**SUSQUEHANNA STEAM ELECTRIC STATION
PROPOSED LICENSE AMENDMENT NO. 285 FOR
UNIT 1 OPERATING LICENSE NO. NPF-14 AND
PROPOSED LICENSE AMENDMENT NO. 253 FOR
UNIT 2 OPERATING LICENSE NO. NPF-22 EXTENDED
POWER UPRATE APPLICATION RE: REACTOR SYSTEMS
TECHNICAL REVIEW REQUEST FOR ADDITIONAL
INFORMATION RESPONSES
PLA-6250**

**Docket Nos. 50-387
and 50-388**

Attachment 2 to PLA-6250
Non-Proprietary Version of the Request for
Additional Information Responses

Figure A.16 0.05 ft² PD SF-BATT TOP 108F
Upper Downcomer Mixture Level

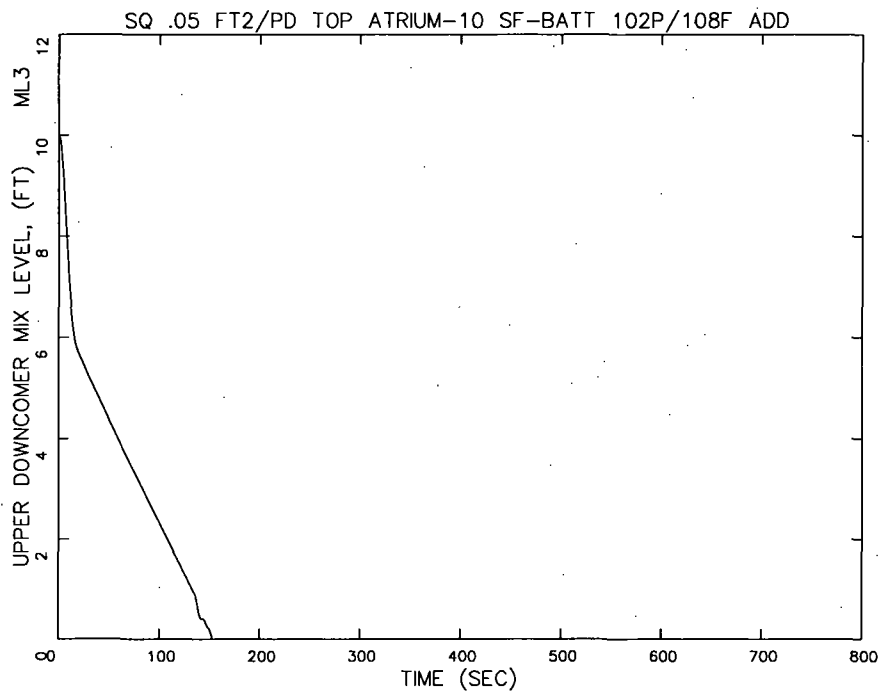
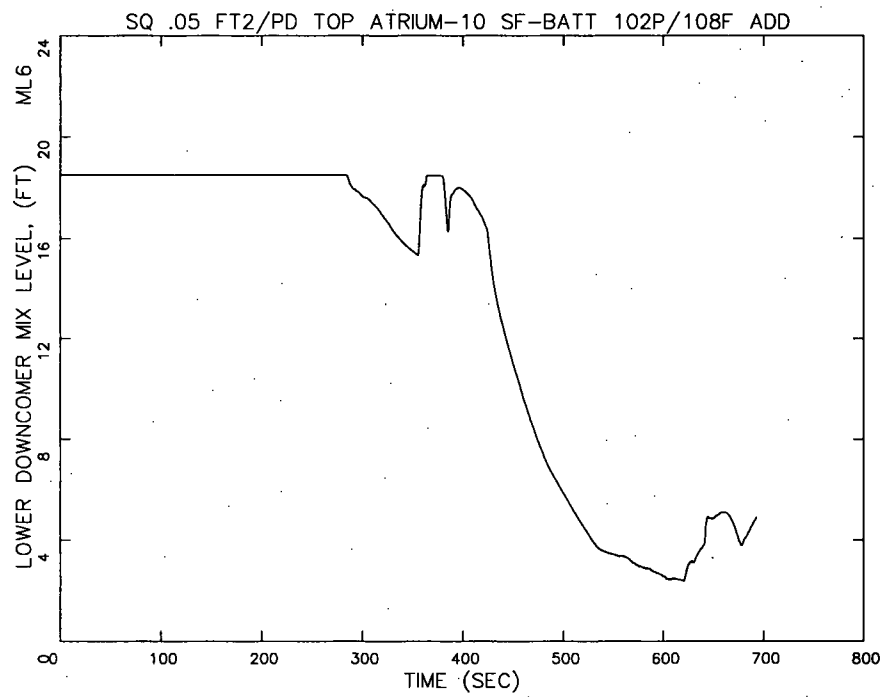
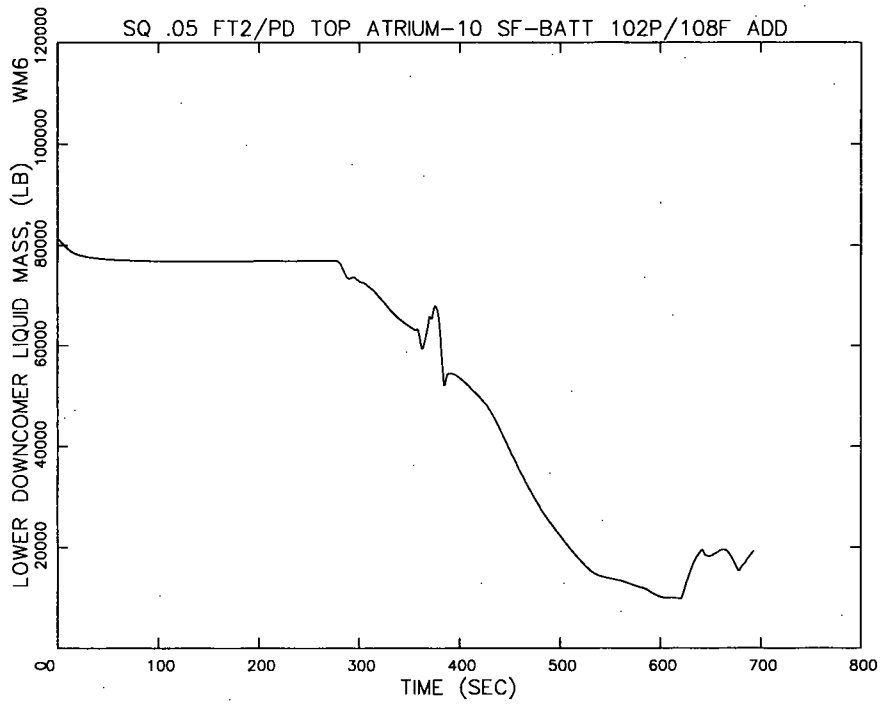
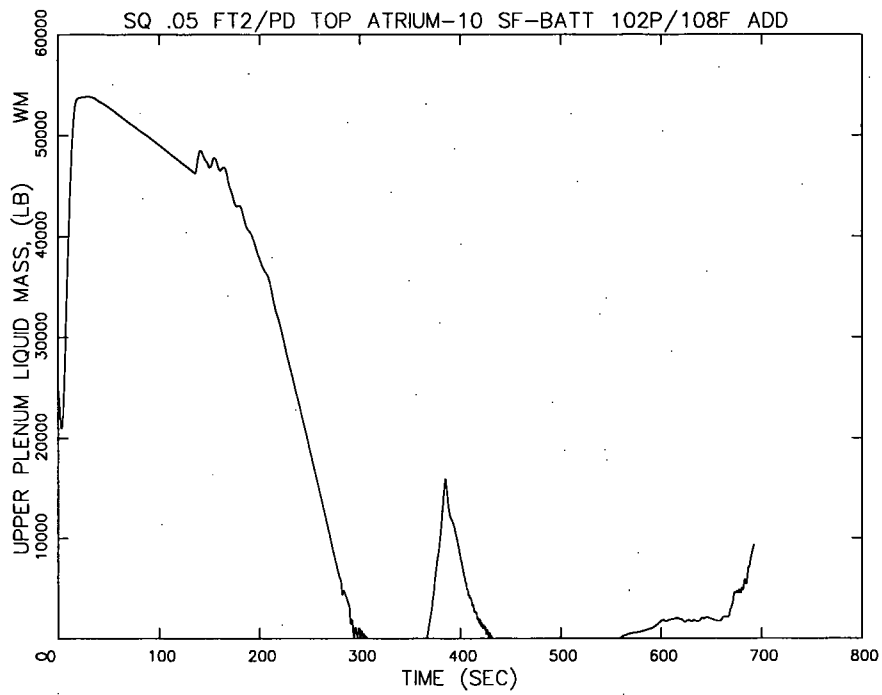
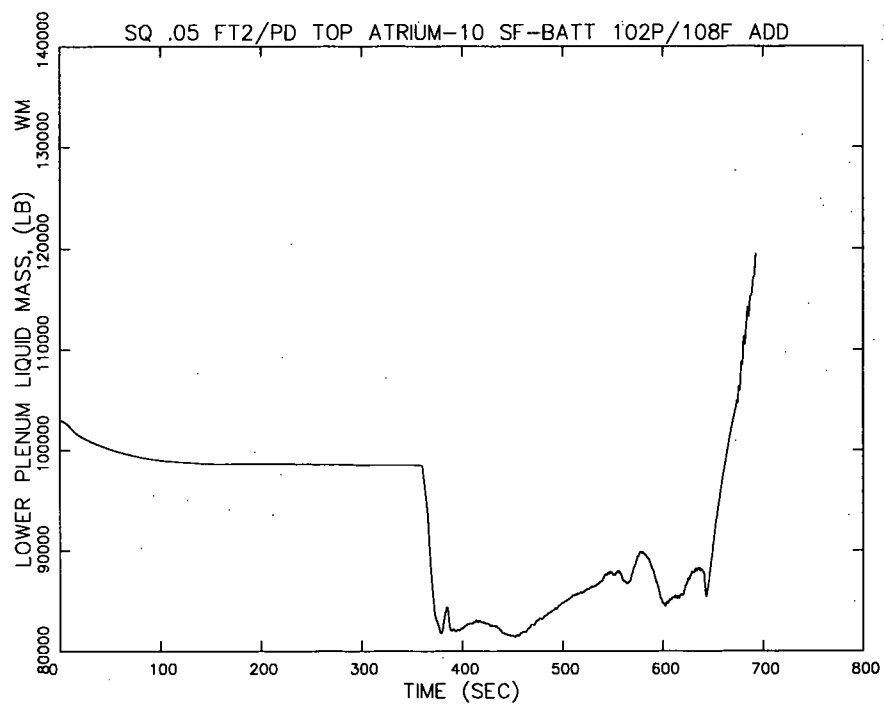
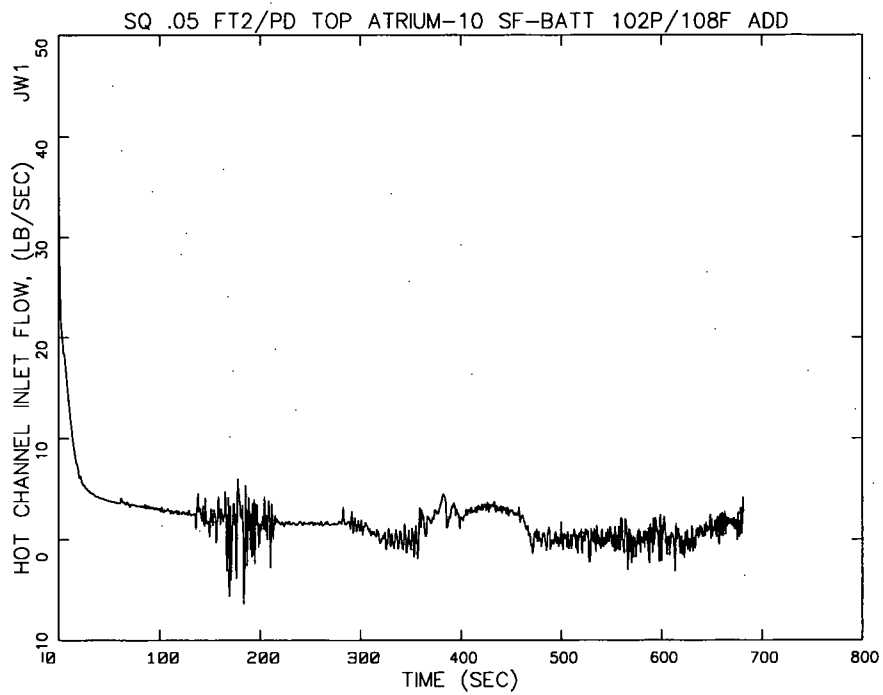
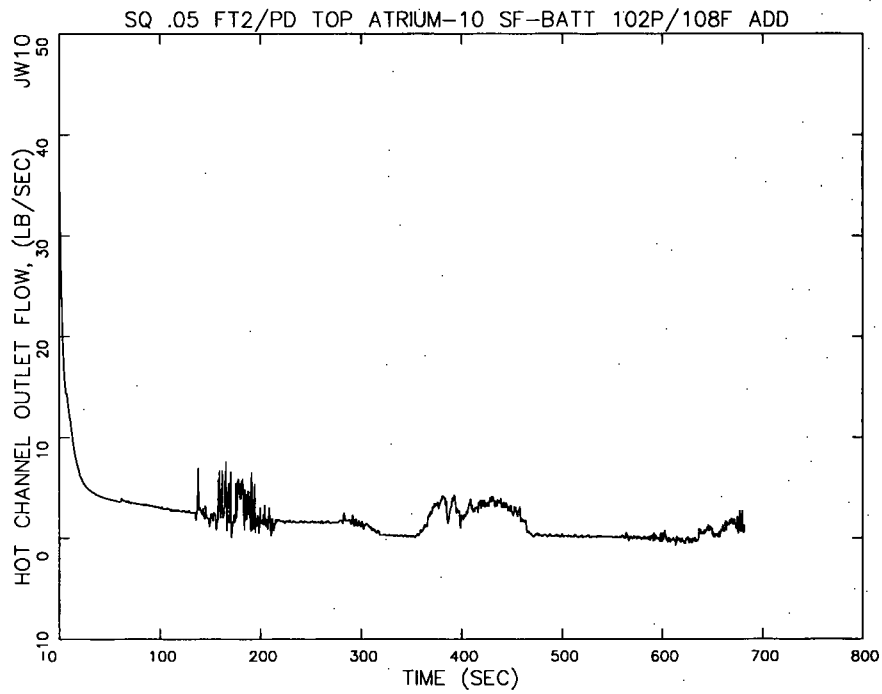
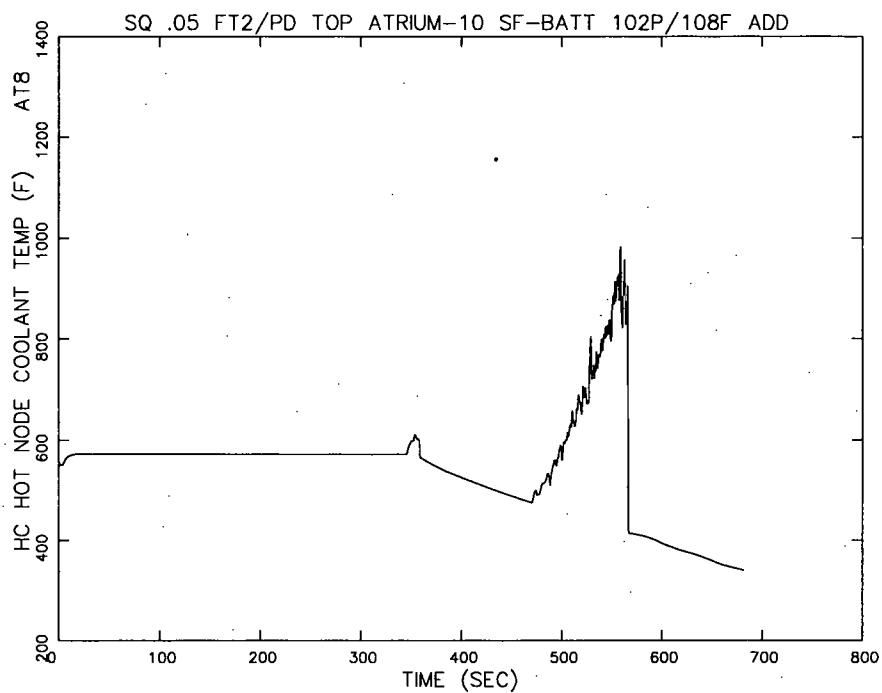
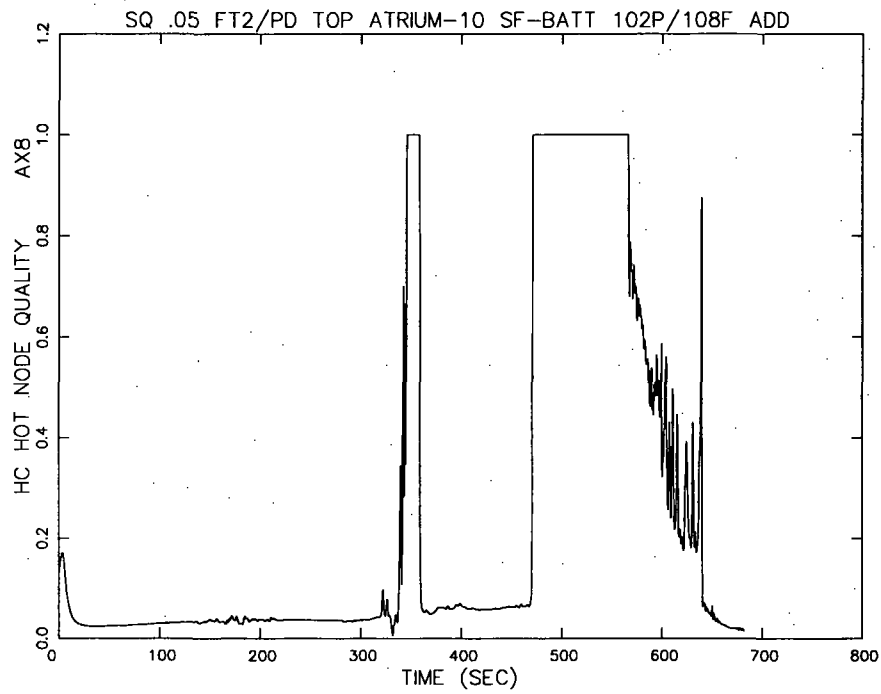
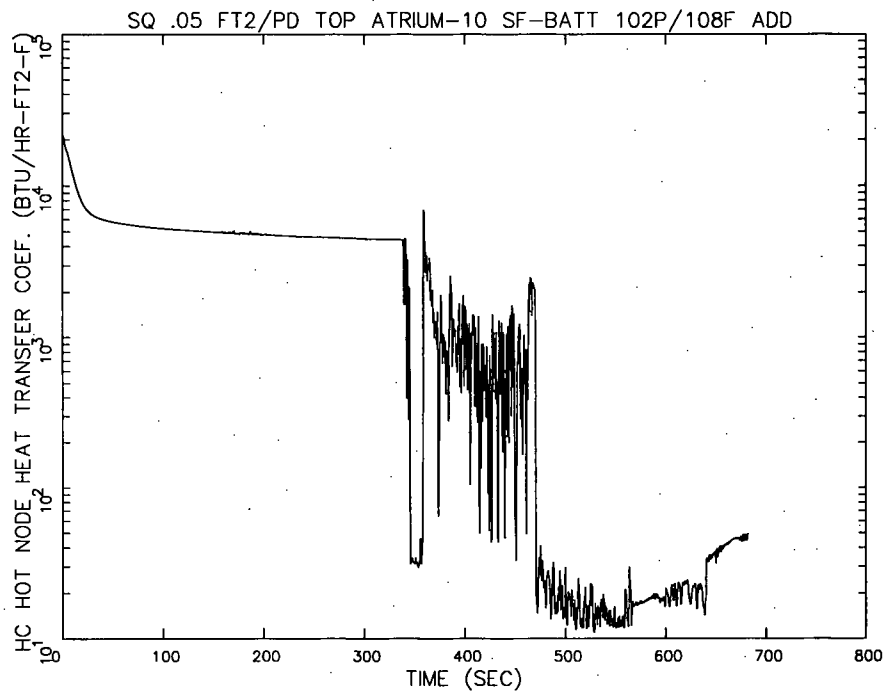
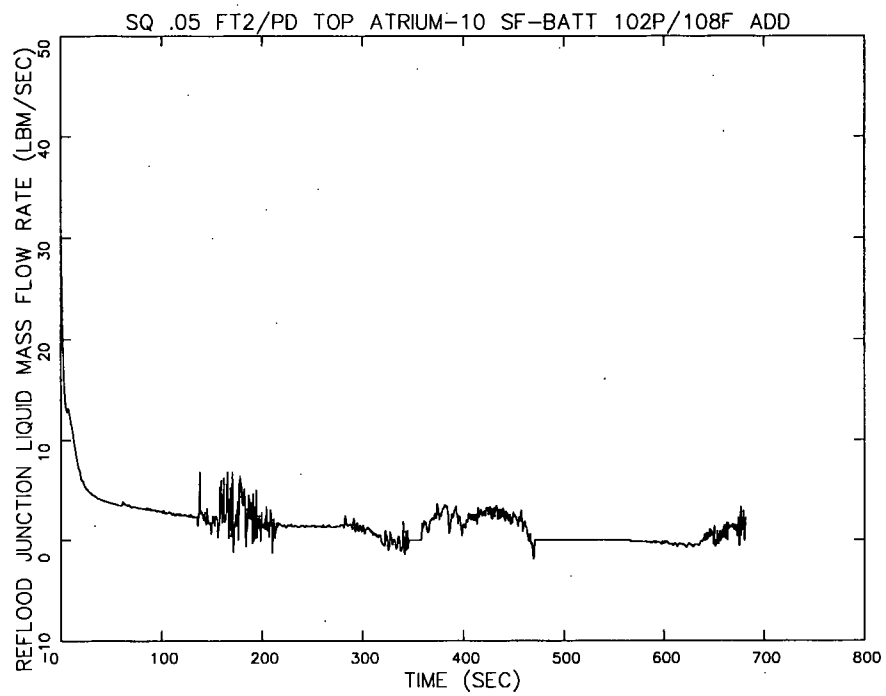
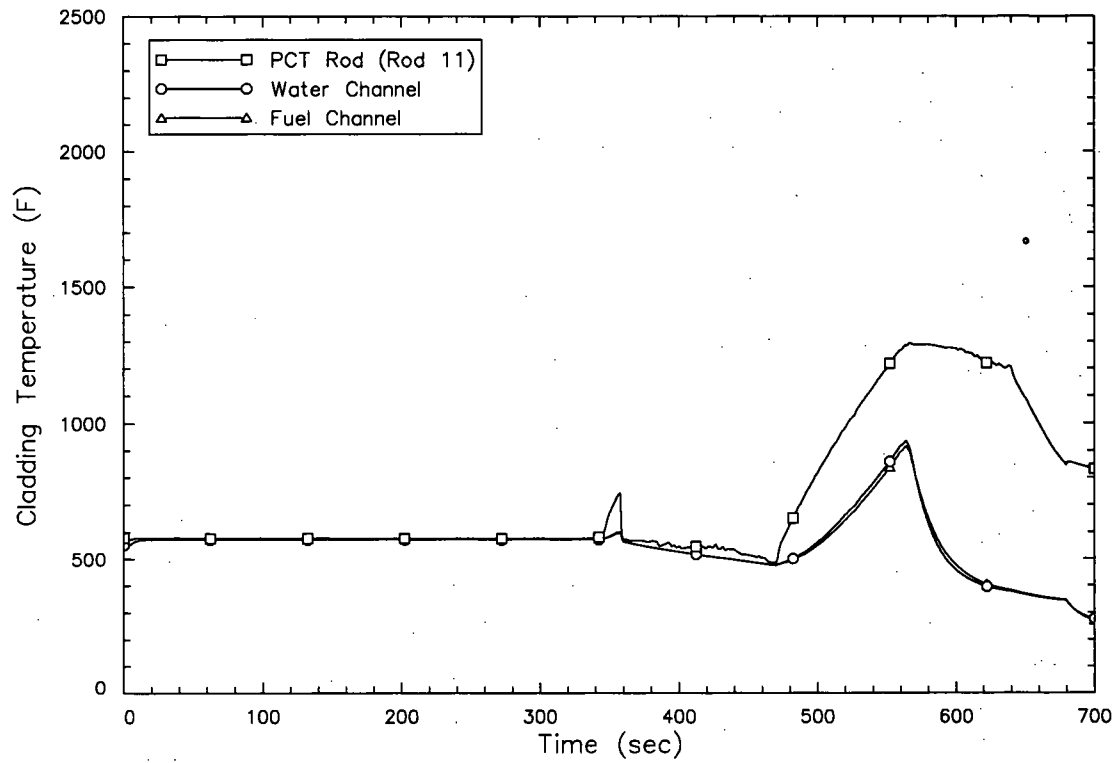
The staff performed a small break LOCA with break size less than 0.1 ft² at recirculation pump discharge side. The break characteristics include initial core flow of 108 Mlbm/hr, 102% power, top-peaked axial power profile and SF-BATT. The staff found the PCT in this break size range (less than 0.1 ft²) is much more limiting compared to break size at 0.7 ft² case. Please provide small break LOCA analysis result at break size of 0.05 ft² with same break characteristics. Please include major parameter plots as shown in the LOCA report (EMF-3242P, Revision 0) for TLO large break LOCA.

AREVA performed the requested small break calculation for 0.05 ft², initial core flow of 108 Mlbm/hr, 102% power, top-peaked axial power profile and SF-BATT. The PCT for this small break was calculated to be 1296°F, which is lower than the limiting large break PCT and lower than the limiting small break PCT calculated with AREVA methods. The sequence of events for the requested small break calculation is provided in Table A.1 followed by a set of major parameter plots similar to the LOCA report.
